**APPLICANT'S RESPONSES TO THE FIRST WRITTEN
QUESTIONS**

**FOR THE DEVELOPMENT CONSENT ORDER
APPLICATION FOR THE ALTERATION AND
CONSTRUCTION OF HAZARDOUS WASTE AND LOW
LEVEL RADIOACTIVE WASTE FACILITIES AT THE EAST
NORTHANTS RESOURCE MANAGEMENT FACILITY,
STAMFORD ROAD, NORTHAMPTONSHIRE**

PINS document reference: 9.2

Application by Augean South Limited for East Northants Resource Management Facility Western Extension

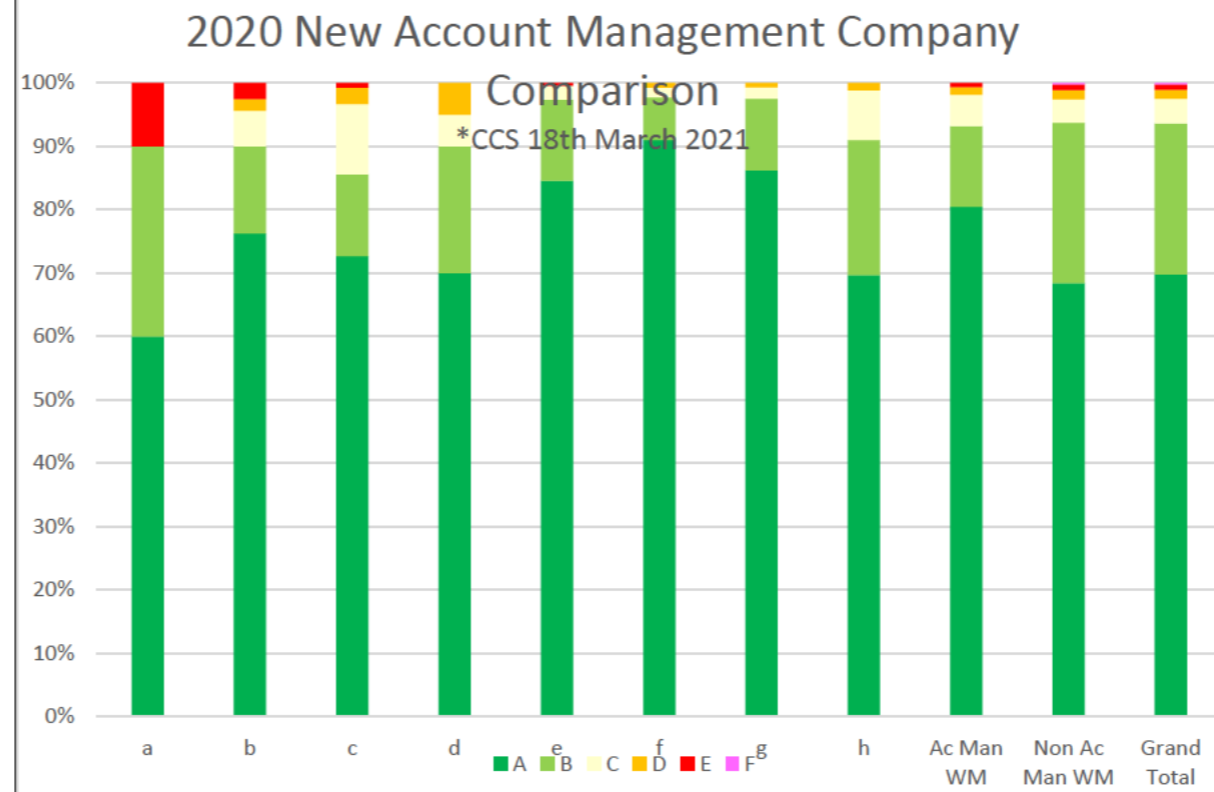
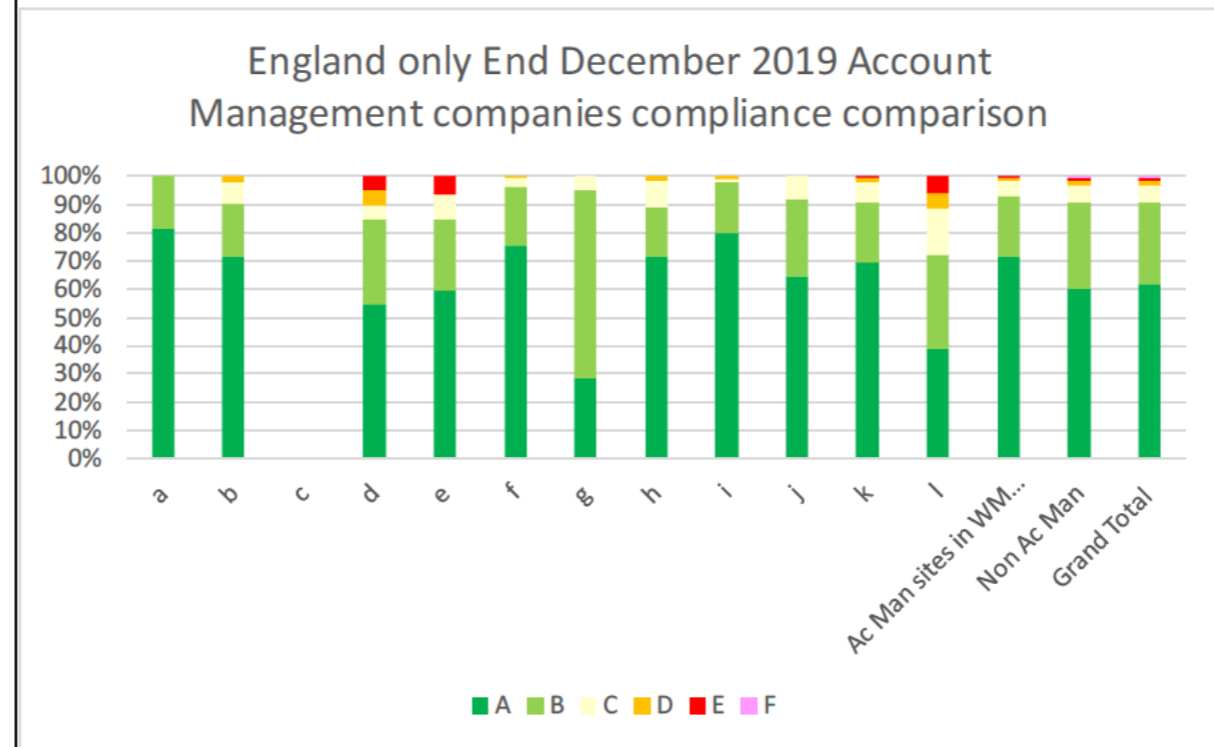
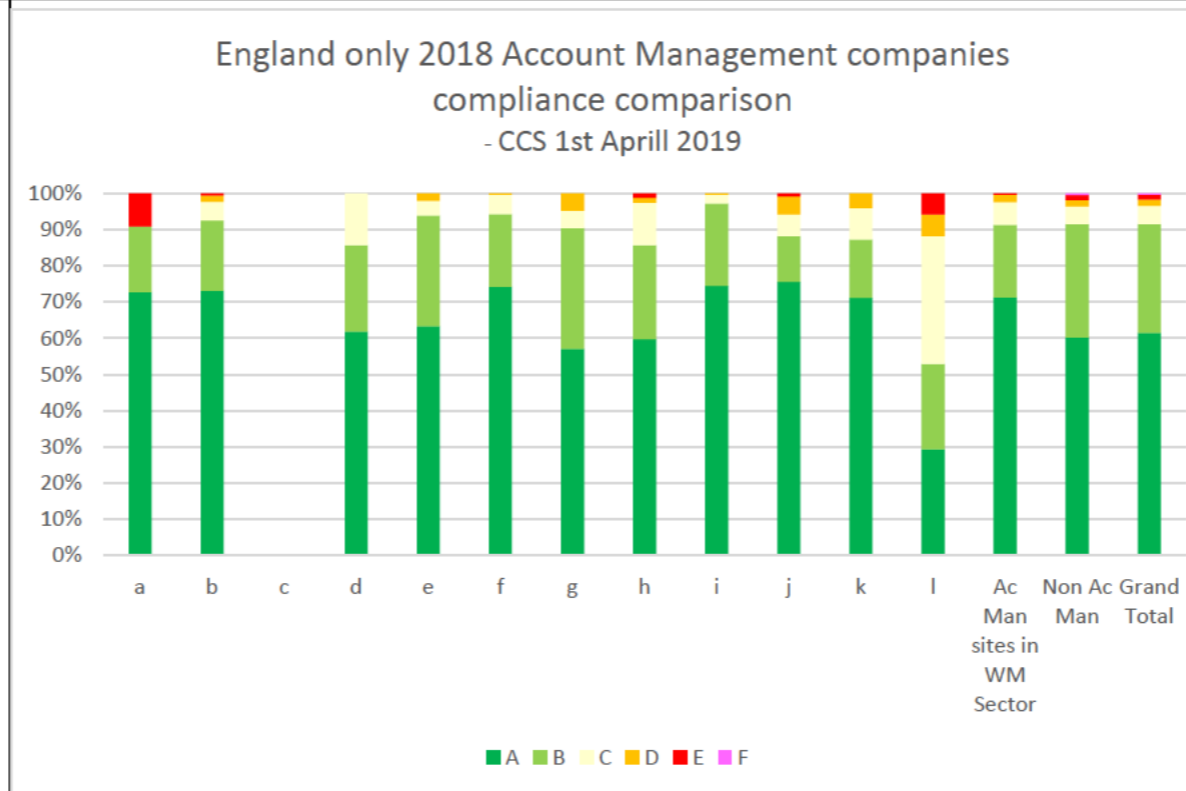
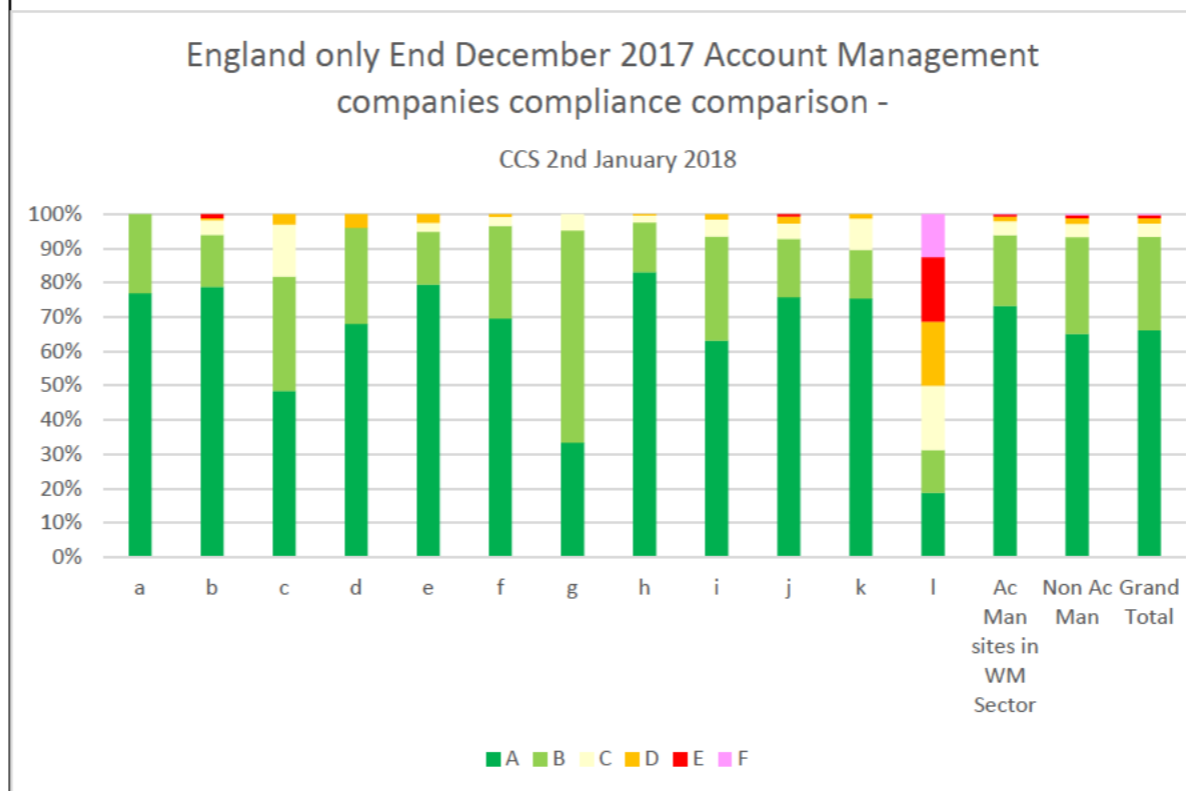
The category E band is for the incident at ENRMF in February 2020.

The category E was for a site at Great Yarmouth due to inconsistencies within the original permit application for the site which no longer reflected the working practices. This has been rectified through a permit variation to ensure the permit is aligned with the site operations. Subsequent inspections of the site by the Environment Agency have demonstrated strong full compliance.
